Product Change Notification

Product Group: Ceramic Capacitors & Non Linear Resistors/August 13, 2008/PCN-NLR-002-2008 Rev A

Adaptation of maximum mounting height (A) for varistors with straight leads

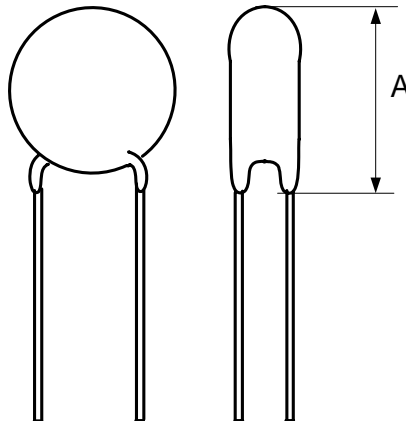
DESCRIPTION OF CHANGE: Vishay has the intention to increase the maximum mounting height (A) for varistors with straight leads.

Part number	Current maximum value A (mm)	New maximum value A (mm)
2381 582 0xxx6 / VDRH05xxxxTSE 2381 582 0xxx7 / VDRH05xxxxASE 2381 582 5xxx6 / VDRH05xxxxBSE 2381 592 0xxx6 / VDRS05xxxxTSE 2381 592 0xxx7 / VDRS05xxxxASE 2381 592 5xxx6 / VDRS05xxxxBSE	9.0	11.5
2381 583 0xxx6 / VDRH07xxxxTSE 2381 583 0xxx7 / VDRH07xxxxASE 2381 583 5xxx6 / VDRH07xxxxBSE 2381 593 0xxx6 / VDRS07xxxxTSE 2381 593 0xxx7 / VDRS07xxxxASE 2381 593 5xxx6 / VDRS07xxxxBSE	11.0	13.0
2381 584 0xxx6 / VDRH10xxxxTSE 2381 584 0xxx7 / VDRH10xxxxASE 2381 584 5xxx6 / VDRH10xxxxBSE 2381 594 0xxx6 / VDRS10xxxxTSE 2381 594 0xxx7 / VDRS10xxxxASE 2381 594 5xxx6 / VDRS10xxxxBSE	15.5	16.5
2381 585 0xxx6 / VDRH14xxxxTSE 2381 585 0xxx7 / VDRH14xxxxASE 2381 585 5xxx6 / VDRH14xxxxBSE 2381 595 0xxx6 / VDRS14xxxxTSE 2381 595 0xxx7 / VDRS14xxxxASE 2381 595 5xxx6 / VDRS14xxxxBSE	19.0	20.5
2381 586 5xxx6 / VDRH20xxxxBSE 2381 596 5xxx6 / VDRS20xxxxBSE	25.0	27.0
